Access Compliance Report

Public Rights-of-Way

(Curb Ramps)

Intersection ID: 27190	Main Street: BALLANTYNE COMMONS PY	Cross Street: WOODVIEW CR	Location: NE
ADA ID: 8511A02A6FBB	Ramp Type: Directional1	Initial Pass/Fail: Fail	Overall Compliance: No
Codes/Mitigation Info/Possible Solution		Field Measurements/Component Compliance	
Severity Score: 13.75

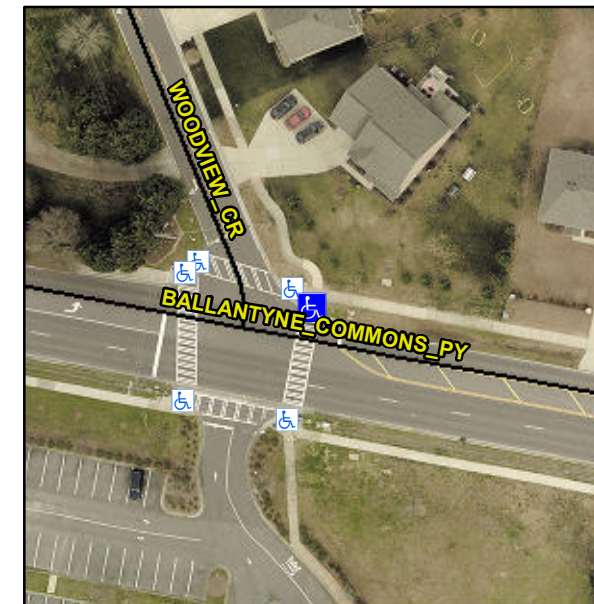
R304.2.2, R304.5.3

Remove & Replace Entire Ramp.
